CITY OF PORTLAND, MAINE

HISTORIC PRESERVATION BOARD

HISTORIC PRESERVATION BOARD MEETING

- i. Preliminary Review of Revised Design Proposal for New Construction, 76 Congress Street (site of former St. Lawrence Church sanctuary); Friends of the St. Lawrence Church, Applicant.
- ii. Preliminary Review of Proposed Alterations, 9 Bowdoin Street; Barbara and Robert Burgess, Applicants.

THEATER: 5,715 GSF
PARISH HALL: 3,360 GSF +
FOOT PRINT: 9,075 GSF

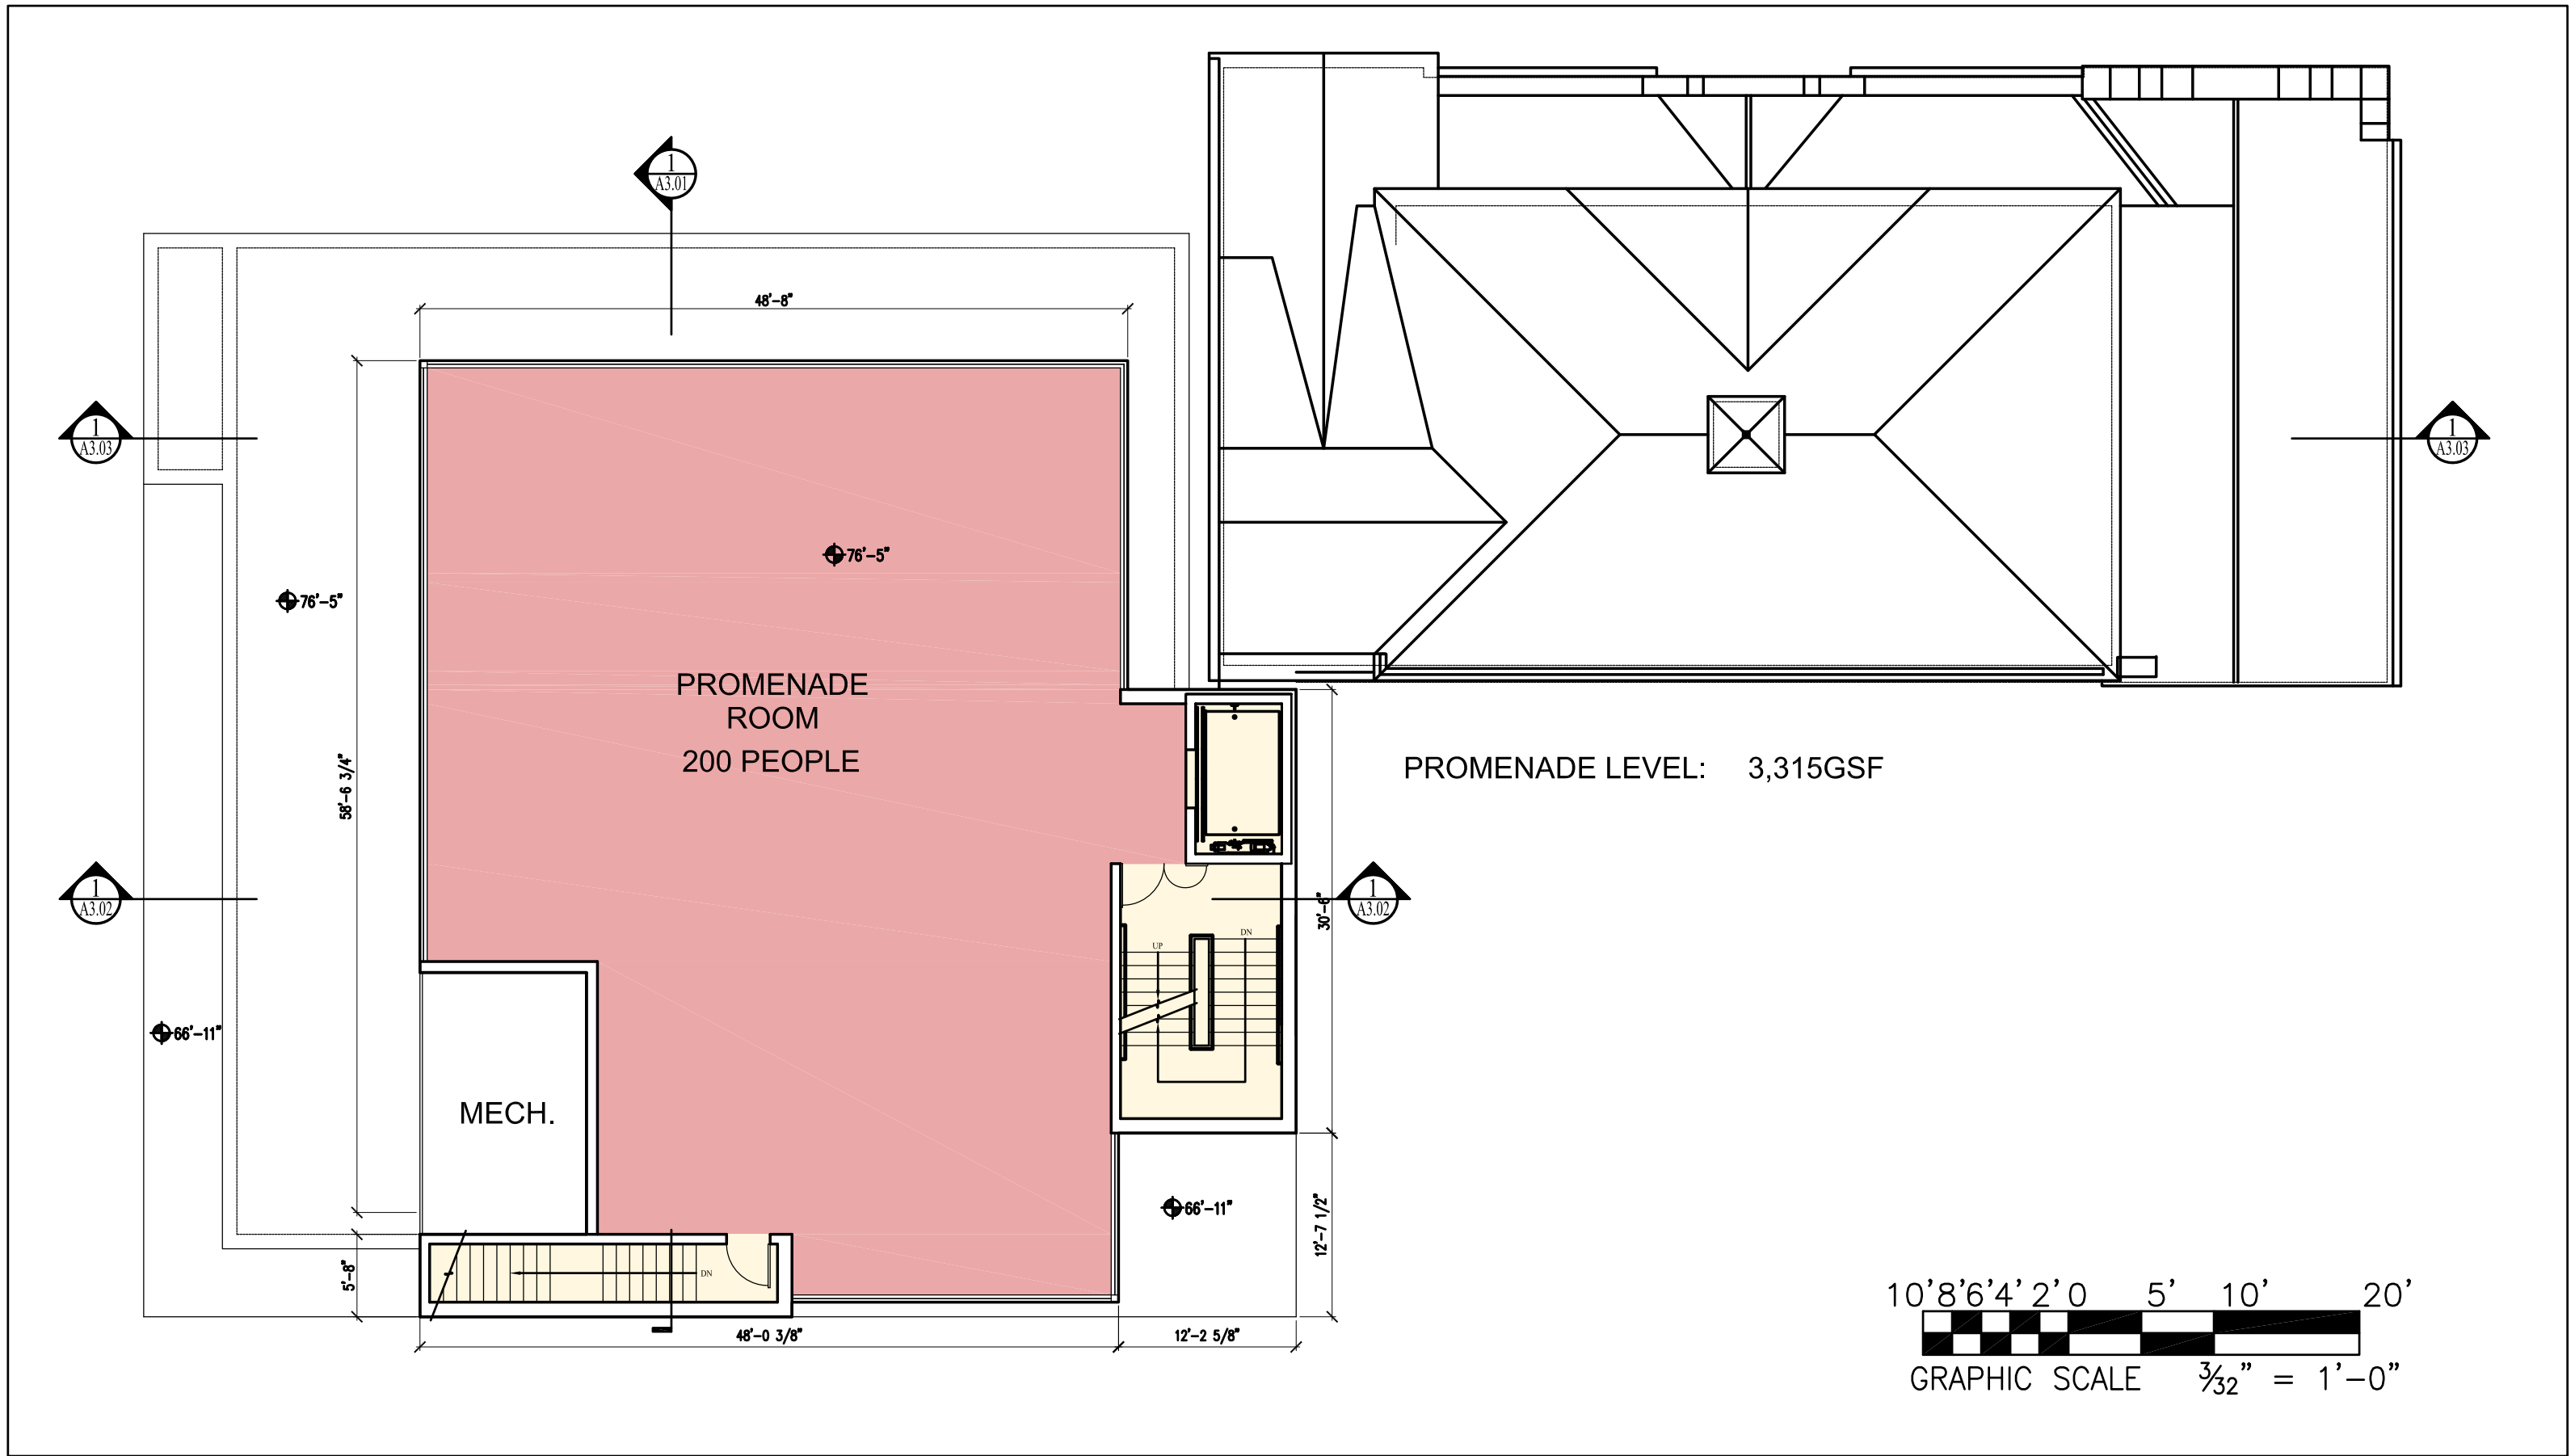
Architect David Lloyd, representing Friends of the St. Lawrence Church, has requested a workshop to present a design proposal for a new addition to the parish hall of the former St. Lawrence Congregational Church at 76 Congress Street. The addition will replace the former church sanctuary which was demolished in 2008.

Note that the enclosed design proposal replaces a previous proposal for the addition that was presented to the Board in 2010. The goal of this preliminary workshop is to provide initial feedback to the applicant and architect on the general scale, massing and design expression of the proposed structure. The Friends of the St. Lawrence will need to embark on an ambitious fundraising campaign in order to build a new arts facility adjoining St. Lawrence's existing parish hall and want to gauge the Board's relative support for the proposed design direction before they present the plans as part of their fundraising initiative.

As Mr. Lloyd states in his letter, the organization received feedback from potential funders that their plans to replicate the original exterior would be inordinately expensive, boosting the overall project costs enormously. Based on this input, the Friends elected to rethink their original plans and hired a new architect to provide design assistance.

recessed and features a glass curtain wall. An elevated plaza is located in front of the recessed glass wall. The upper floor of the building appears to be a sheer-walled rectilinear box. According to the project architect, a perforated metal skin is being considered for the exterior siding. Lighting is also being explored for behind the skin. The top floor, which is set back slightly from Congress Street and considerably from Munjoy Street, is a 10' tall glass-walled space. As planned, it will function as a community meeting room.

ARBOR ENTRY ELEVATION
1/2" = 1'-0"

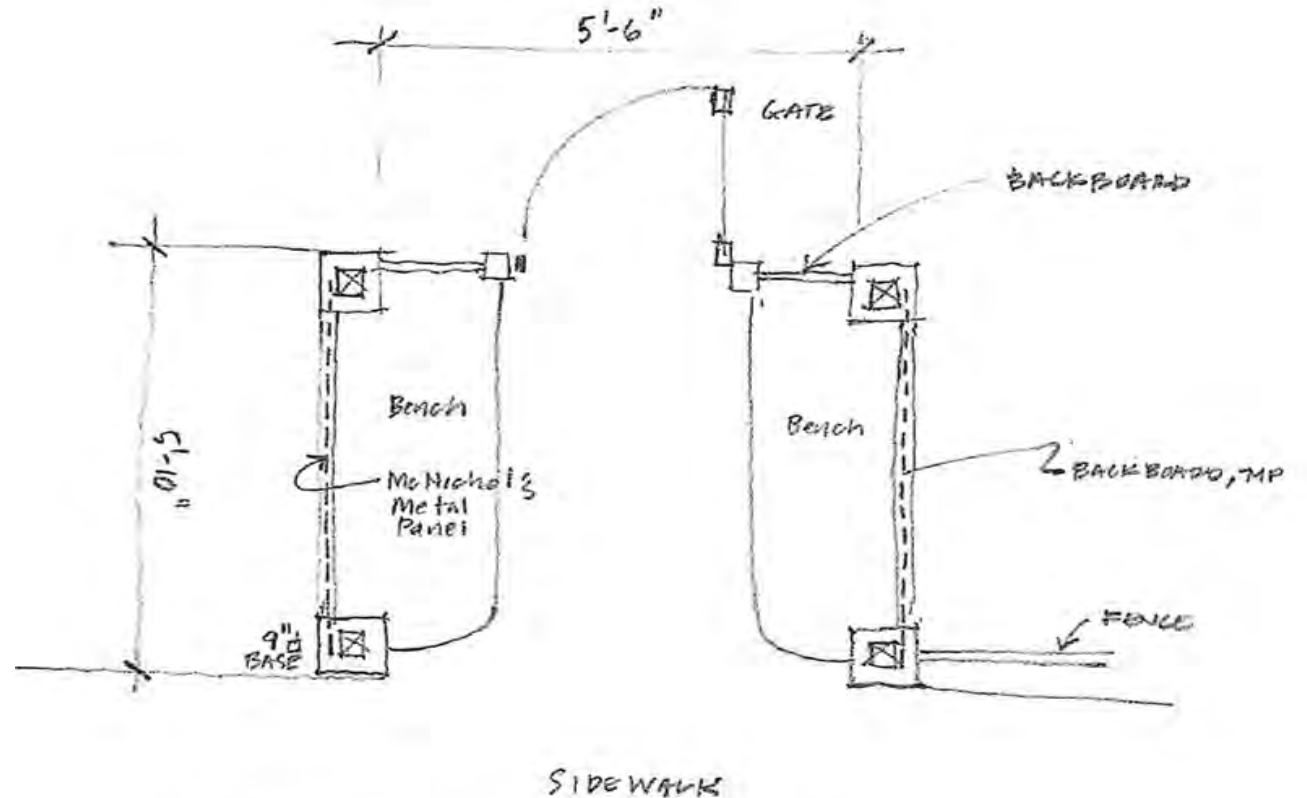
Plans call for a dark-colored metal fence around the house and eastern two thirds of the yard. Along the east boundary, there is a hedge and only room for paved walk between the house and the neighbors at 18 Neal Street, but along Bowdoin Street a recessed gate is proposed, with granite piers and wooden benches in the recess (see drawings.) The existing brick walk is to move west, to occupy part of the driveway space now paved with asphalt. Staff supports creating a useful and attractive yard that complements the house, and also recommends taking

a simple approach that will neither distract from or obscure the house. Board members may wish to comment on the compatibility of granite posts and niche seating in the gate alcove with the character of the property.

D. Espalier Fence at Garage

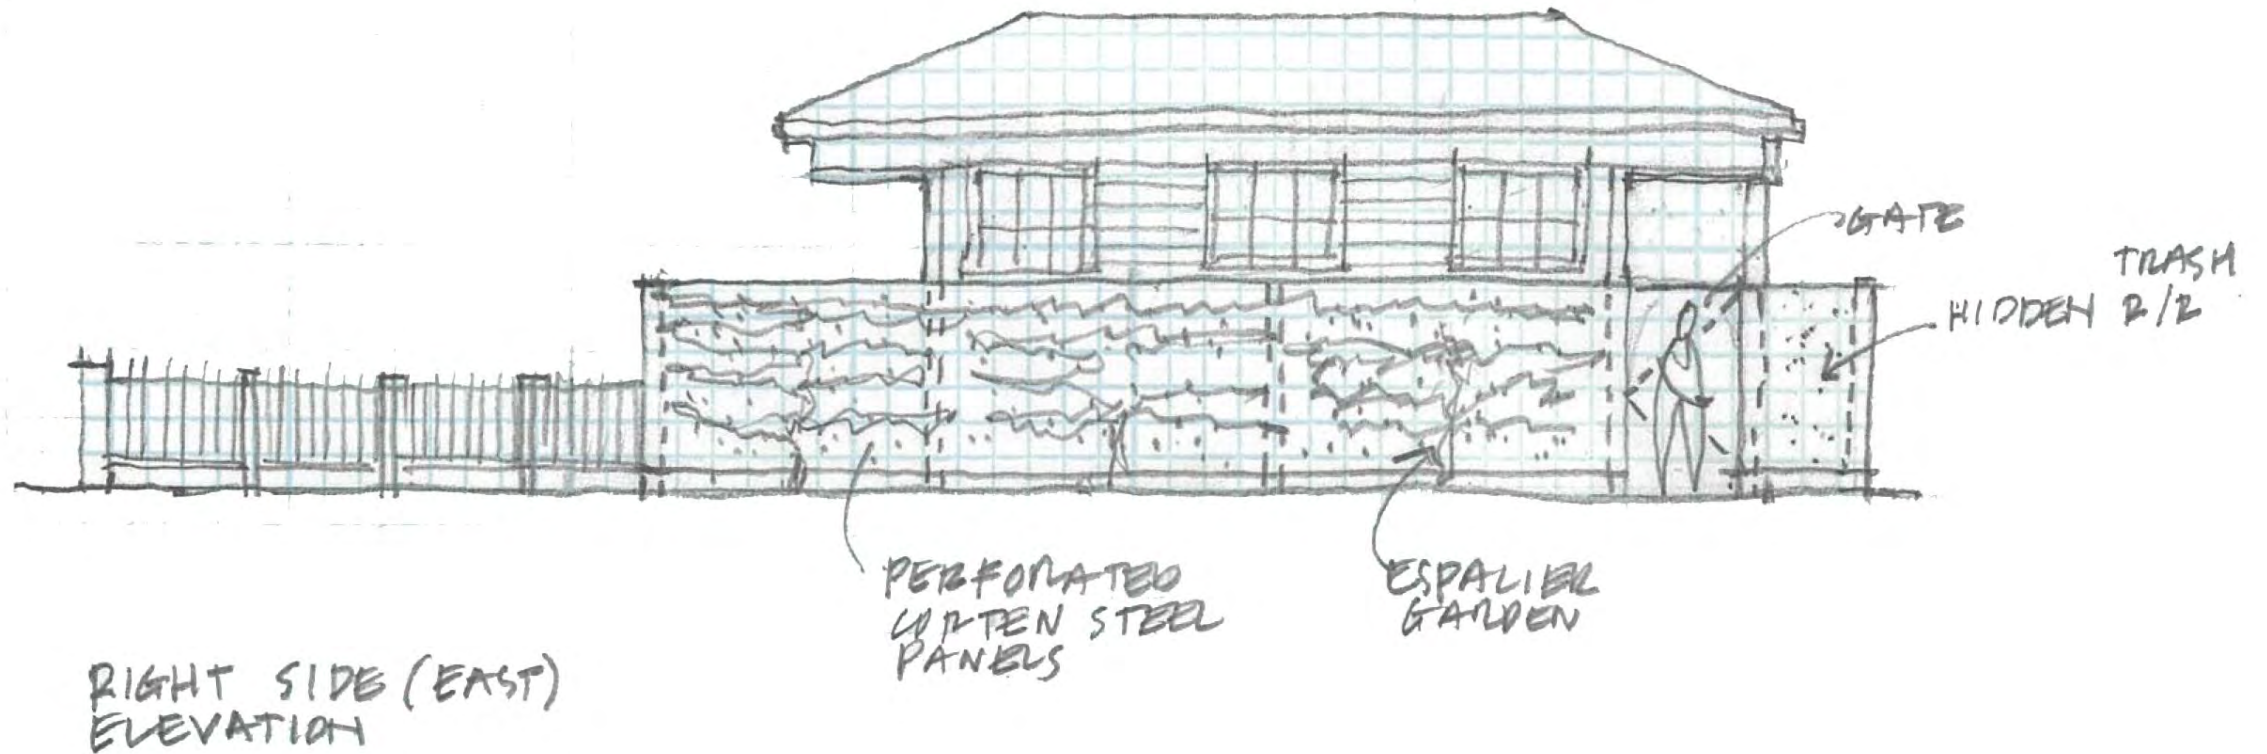
An extra parking spot on the east side of the new garage will use the same new 12’ wide curb cut as the garage. Parking and the garage are proposed to be screened from the house and core of the yard by a perforated fence of Corten, designed to serve as a lattice support for vegetation. Though the rust-colored steel would be covered by plants for at least part of the year, staff would question the use of the material in this residential, West End setting in a highly visible location. (A low curb of Corten is also proposed to enclose garden beds on either side of the main entry landing.)

Folly (Existing Garage – Adaptive Reuse)

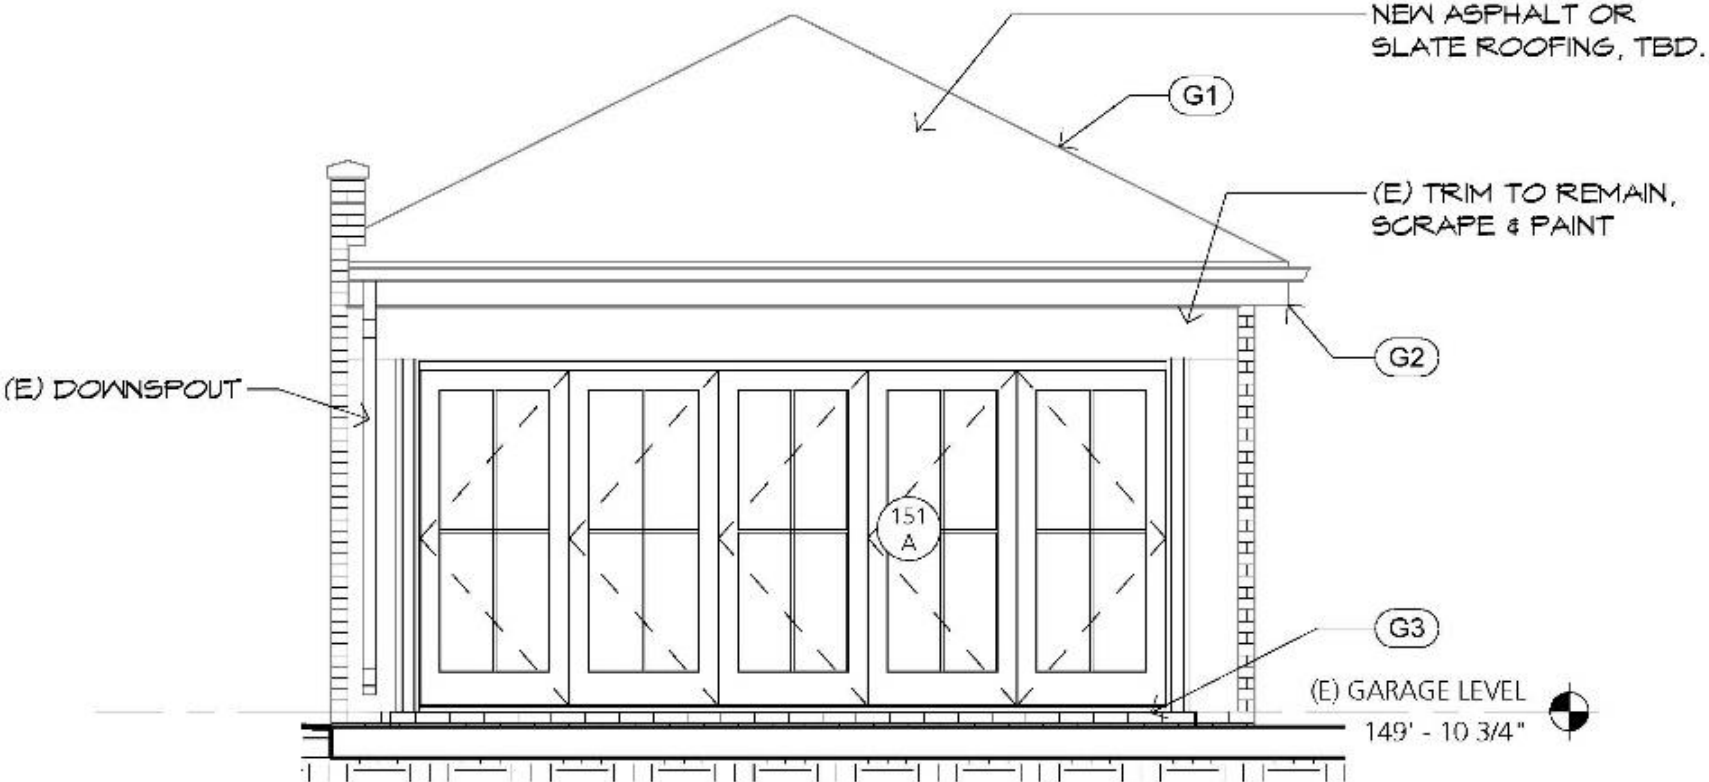
The existing garage is a low, hip-roofed building at the rear of the lot which appears to date from after 1924, but it is compatible with the character of the house. There may have been alterations to the building in the past, but the history is unclear. The current double garage door is not original. To repurpose the structure as a folly, or garden house, the architects propose to replace the front door with a five-panel folding door system that is predominantly glass. The transparency will certainly change the appearance, but otherwise the building will look the same, and staff is not concerned by the adaptive re-use of the structure at the back of the yard.
